## **Proposal for Supplement 1 to the 01 series of amendments to Regulation No. 138**

Figure 7b Test procedures for measurement of frequency shift, Method A

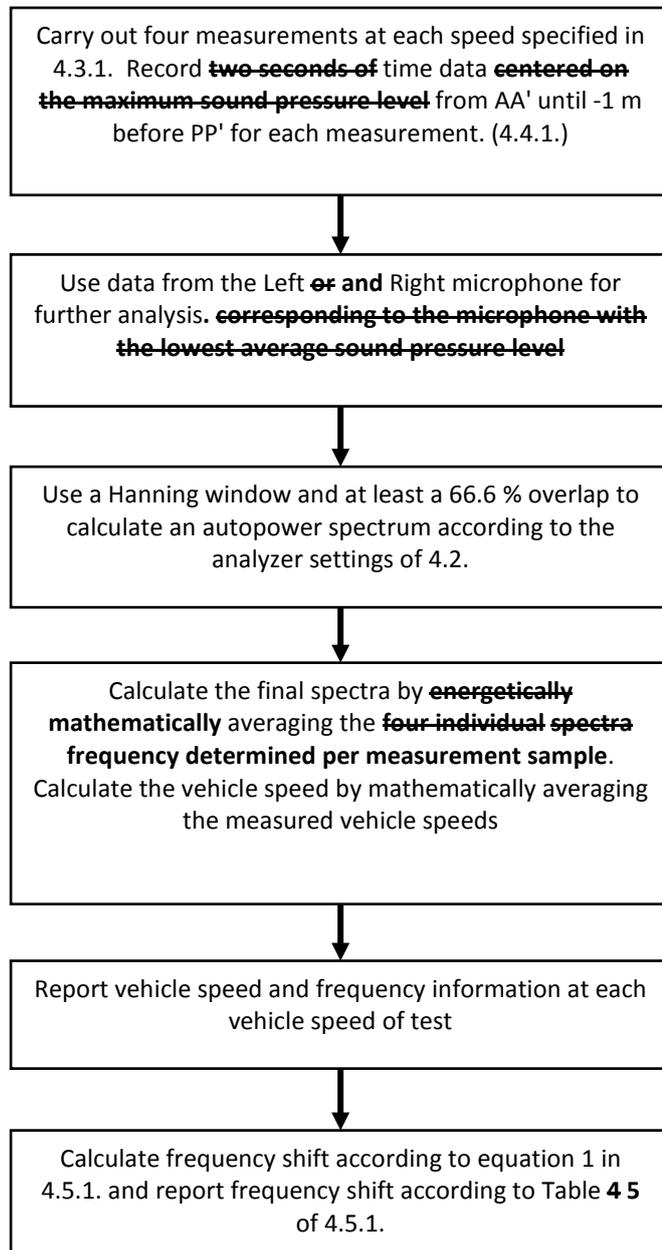
Appendix to Annex 3 Figure 7b, amend to read:

A3 App. The flowcharts have been amended to reflect the regulation text.

Test procedures for measurement of frequency shift, Methods B, C, D, and E

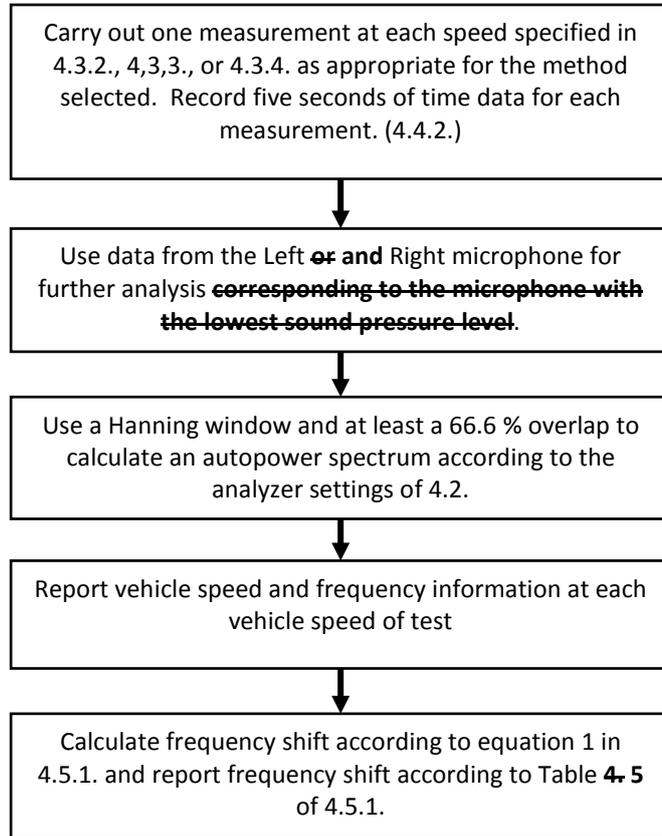
Appendix to Annex 3 Figure 7c, amend to read:
